AGENDA
CITY OF CEDAR FALLS, IOWA
PLANNING AND ZONING COMMISSION
WEDNESDAY, JANUARY 24, 2018
5:30 PM AT CITY HALL - COUNCIL CHAMBERS

TO: Planning & Zoning Commission
FROM: Shane Graham, Planner II
DATE: January 19, 2018
SUBJECT: College Hill Neighborhood Site Plan Review – 2119 College Street

REQUEST: Request to approve a College Hill Neighborhood District Site Plan Review for a new multi-use building at 2119 College Street.

Building Height Comparisons

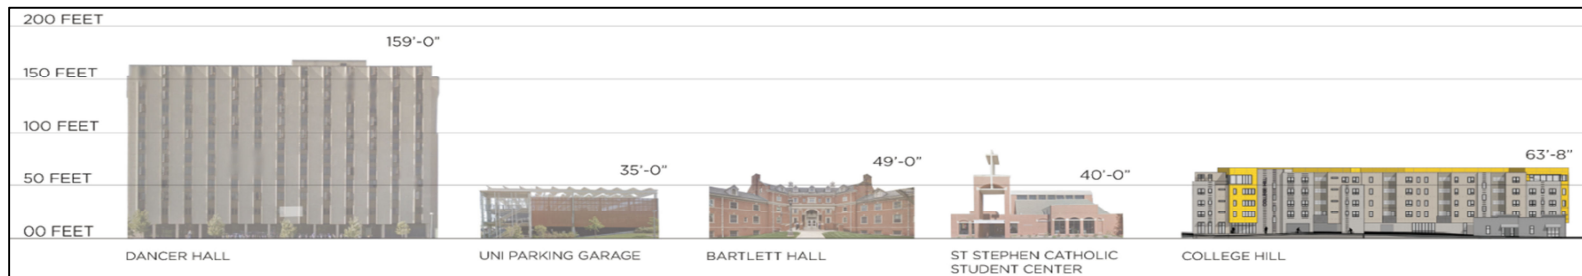
Most of the buildings in this immediate area are either one-story or two-story in height. The proposed building will be 5 stories in height, which would replace two existing two-story structures and one existing single story building that are currently on the property. The property is zoned C-3 Commercial District, which has a building height limitation of 165 feet or three times the width of the road that the building faces. In this case College Street is 40 feet in width, meaning that the maximum building height allowed would be 120 feet (40 feet x 3). As this structure would be 63 feet 8 inches in

The applicant has provided a diagram which shows several other buildings within a 2-3 block area that are taller than the proposed building (see attached diagram for building locations). In the diagram, it shows the proposed building with a height of approximately 64 feet. Other buildings in the area and their heights include the St. Stephen Catholic Student Center on W 23rd Street at 40 feet in height, Bartlett Hall on the UNI campus on W 23rd Street at 49 feet in height, the UNI parking garage on W 23rd Street at 35 feet in height, and Dancer Hall on Campus Street on the UNI campus at 159 feet in height. Also, the applicant has provided a side elevation diagram which shows the street section of buildings located on College Street and their height comparison to the proposed building. Based on the diagrams presented below, staff feels that the building scale and height will not be out of character for the area, as there are other structures within the neighborhood that are comparable in scale and height to the proposed building.

height, it would meet the height requirement of the Zoning Ordinance. This property is also located within the College Hill Neighborhood Overlay Zoning District. This overlay district does not have a specific height limitation for buildings, but it does call for reviewing the scale of a proposed building in relation to adjoining properties and other nearby properties within the immediate neighborhood.

East (College Street) Elevation

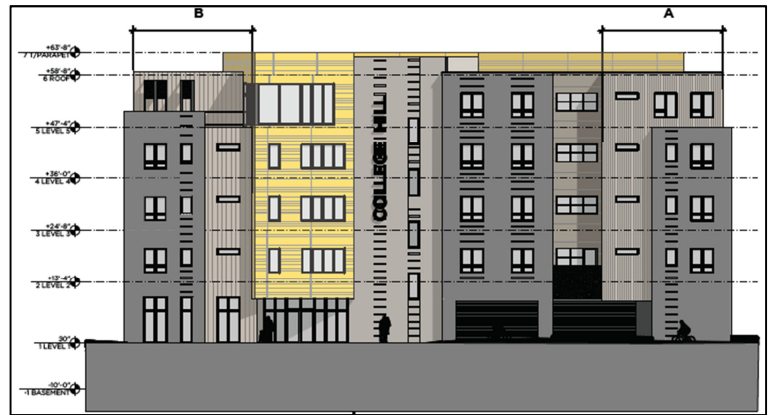
The proposed building will have a more modern look, as it will be constructed with a mix of metal paneling, sandblasted concrete, brick and perforated metal screens. Each of the four sides of the building will have a slightly different design in relation to the amount and type of materials used. Please see the table below which breaks down the use of materials by building side.

Side of Building	Brick	Metal Paneling	Concrete	Openings
North	50.2%	35.9%	0%	13.9%
South (W 22 nd St)	36.7%	27.5%	18.3%	17.5%
East (College St)	54.5%	23.9%	0%	21.6%
West	31.5%	54.6%	0%	13.9%

GROUND FLOOR

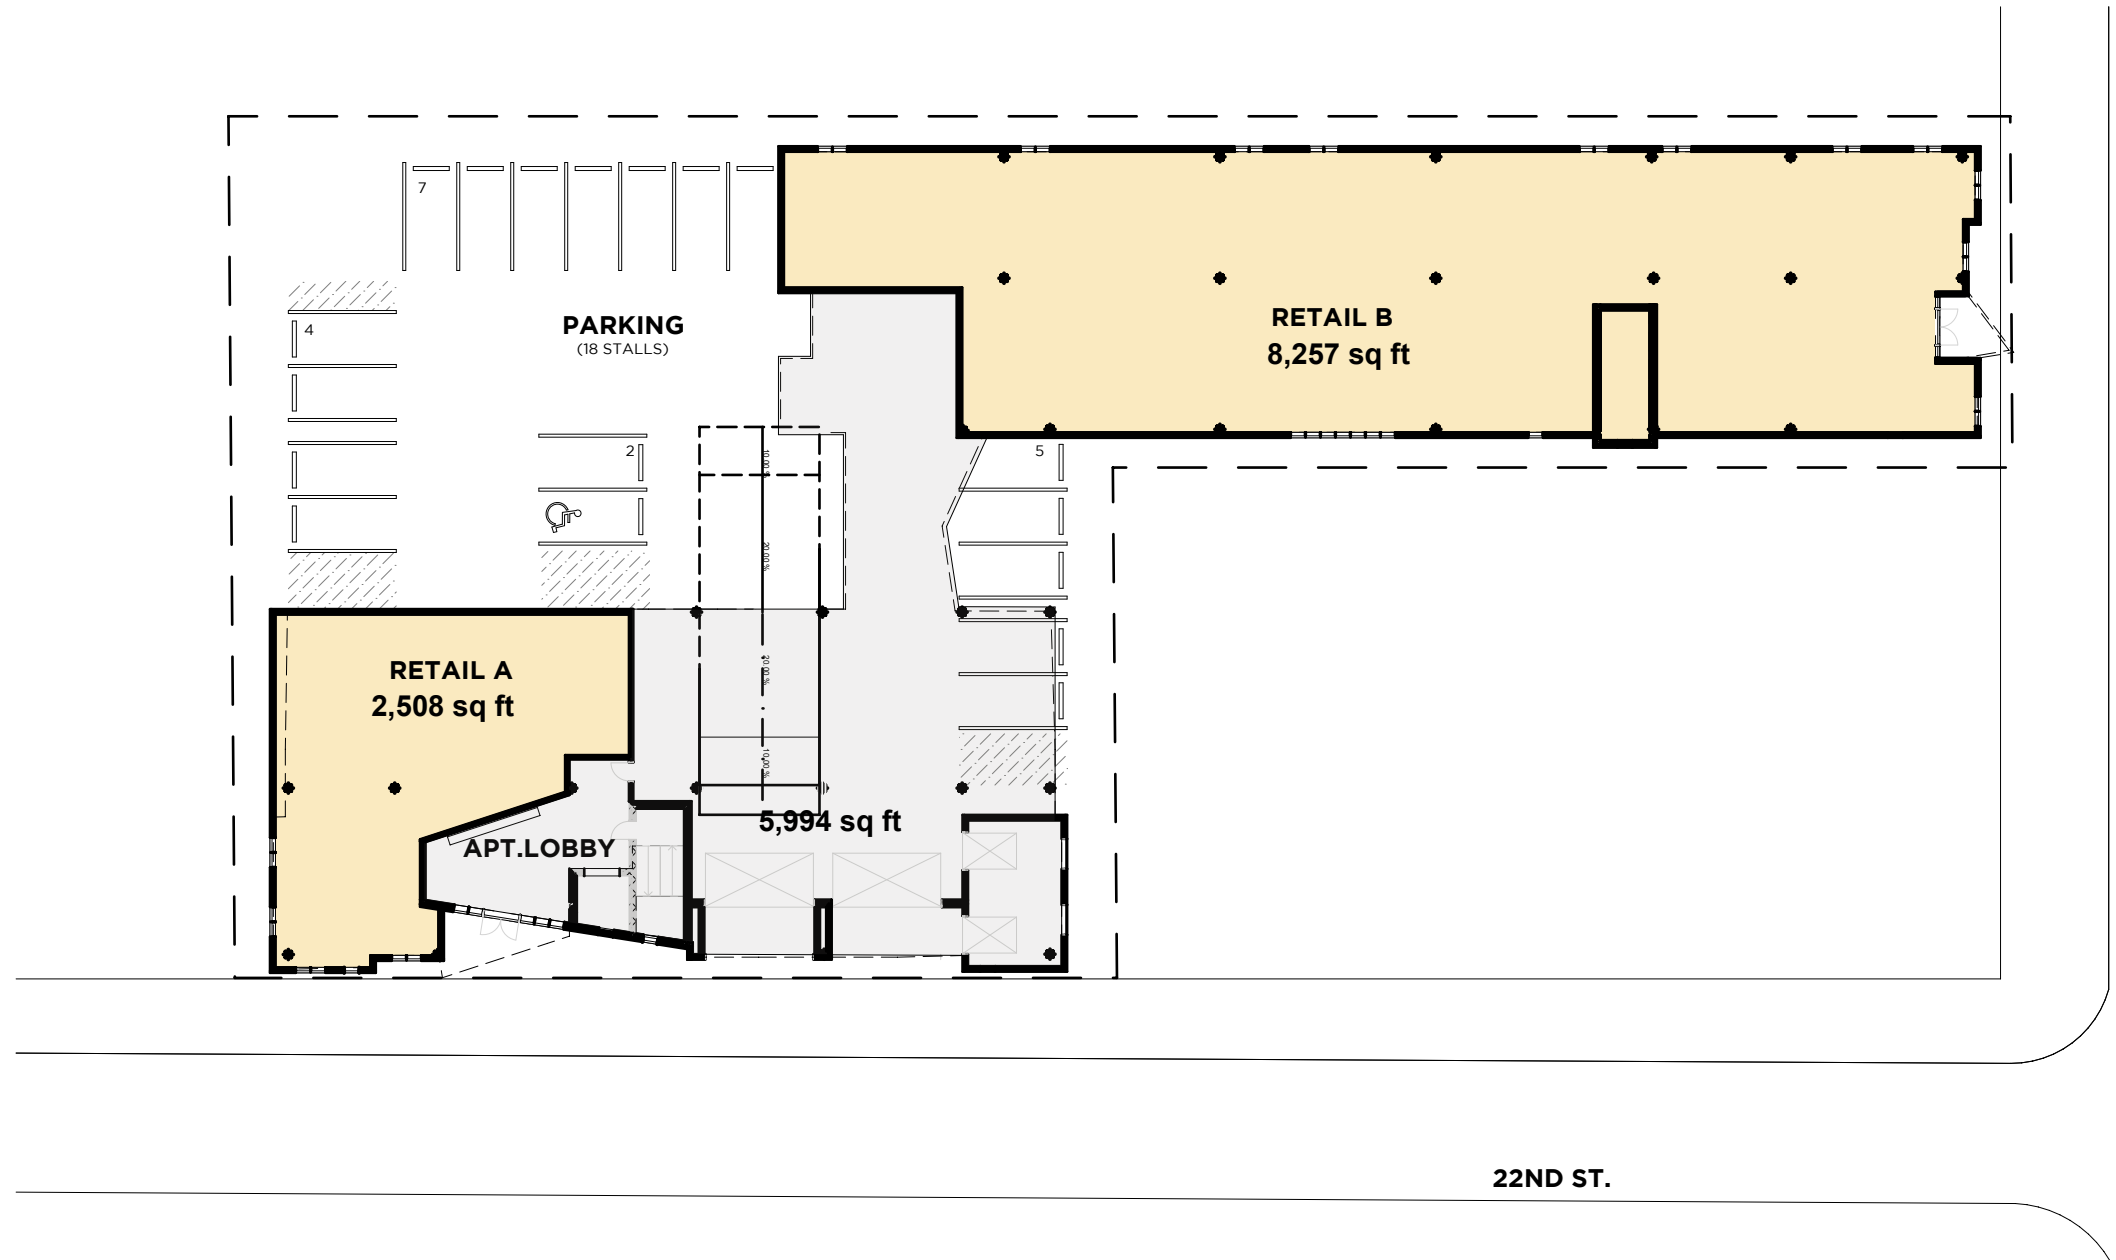
When the developer submitted the initial site plan, staff deemed the use primarily residential based on the fact that a majority (over 50%) of the ground floor was dedicated to a residential use. However, the revised site plan does show a majority of the ground floor area dedicated to commercial use (64%). Past interpretations on site plans located at 2024 College Street (2014), 2215 College Street (2014), 917 W 23rd Street (2016), 200 W 1st Street (2017), and the River Place Development along State Street (2014) have determined their principal use based by the first floor area. Therefore, staff deems this to be a principal commercial use.
